May 5, 2016

Re: Second Environmental Assessment Letter  
Frey Farm Landfill Vertical Expansion  
Permit No. 101389  
Manor Township, Lancaster County

The Department of Environmental Protection (DEP) has reviewed your response to our initial environmental assessment review of your application and has the following comments:

# USGS Seismic-Hazard Map Contours for the Conterminous United States, 2014

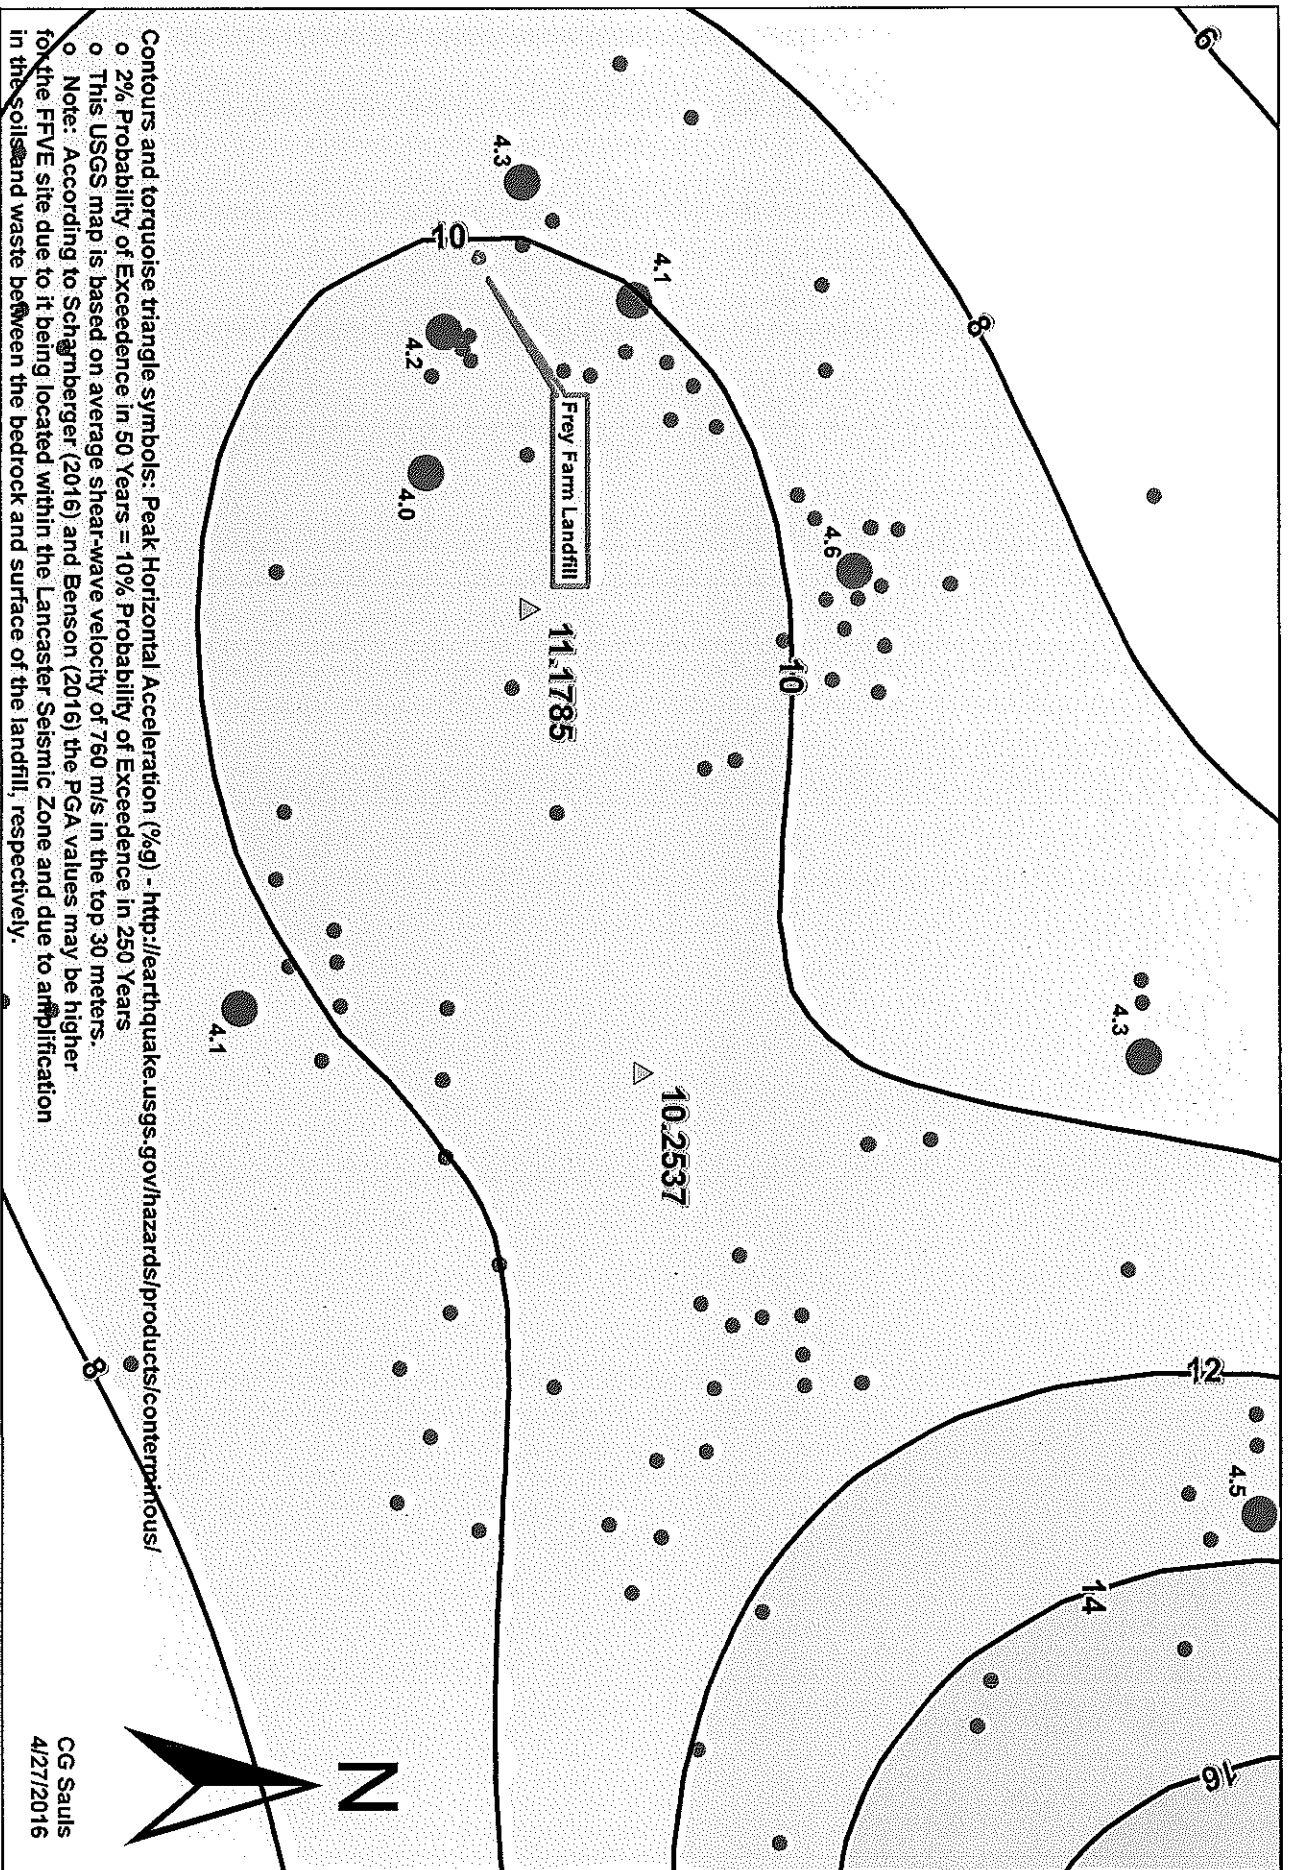
- (1) The updated USGS 2014 Seismic-Hazard Map, used by PADEP to create the attached GIS maps, indicates that the FFVE is located at a seismic coefficient  $>0.10g$  PGA (based on an average shear wave velocity of 760 m/s in the top 30 meters). As a result of this higher value and subsequent supporting documentation indicating an even higher PGA of 0.20g as suggested by Benson (2016), the FFVE design and cross-sections pertaining to the Phase II *Form 24* section of the Permit Application will need to be revised due to the original design calculations being based on the use of a lower seismic coefficient of 0.10g PGA. Additional discussion regarding PGA values is provided in subsequent comments, including the Benson (2016) and Scharnberger (2016) reports.

- (a) The 2014 USGS Seismic-Hazard Map indicating that the FFVE site is documented in an area with a seismicity coefficient  $>0.10g$  PGA and not less than nor equal to the  $0.10g$  PGA contour as documented by ARM in the Permit Application and the March 7, 2016 response, respectively. As a result of expected PGAs  $>0.10g$  in the vicinity of the proposed FFVE, a seismic impact analysis as defined by Federal Subtitle D regulations will be required and Form 24 will need to be revised.

Note: According to Schamberger (2016) and Benson (2016) the PGA values may be higher for the FFVE site due to it being located within the Lancaster Seismic Zone and due to amplification in the soils and waste between the bedrock and surface of the landfill, respectively.
